Technical Note

Project Number: T24544
Project: Market Bosworth
Title: TN01 – Response to LCC
Date: 24/06/2025
Prepared By: Jasmin Rema

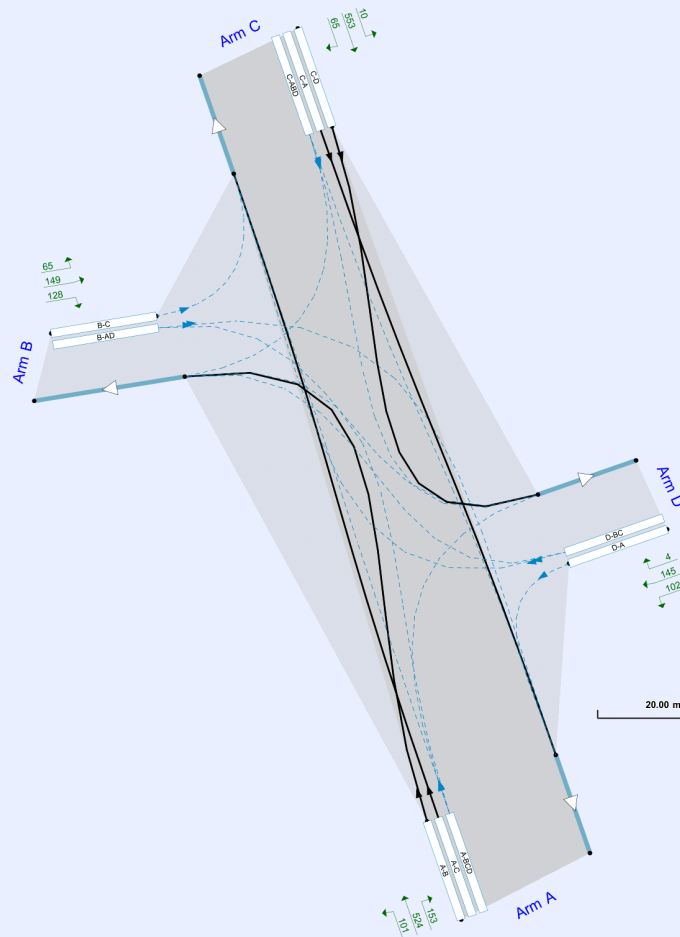
- *After reviewing the junction modelling, the LHA can advise the following points:*
- *The main road widths entered should be reduced as they include the width of the right turn lanes. The right turn lane widths should be omitted as stated on page 370 of the user guide.*

- *It is advised that right turn blocking queue lengths are entered for the right turn lanes on the A447 (15 pcu for the north side, and 13 pcu for the south side).*

- *Bosworth Road – The hatching should not be assumed to be used as a flare lane (the guide states hatching should not be counted in any measurements of geometry). For this approach, the “Estimate Flare Length” box should be ticked with 5m interval side road widths entered that exclude hatching.*

- *Bosworth Lane – The acceleration lane should not be justification to model this approach as two lanes. The 5m interval side road widths should be entered, and the approach should be modelled as a single lane.*

- *Values in the Vehicle Mix table should be entered (HGV %).*

1.24 In line with the above comments, the geometries for the staggered junction have been revised, and the file outputs for the A447/ Bosworth Lane/ Bosworth Road/ Ashby Road junction assessment can be seen in **Appendix A**.
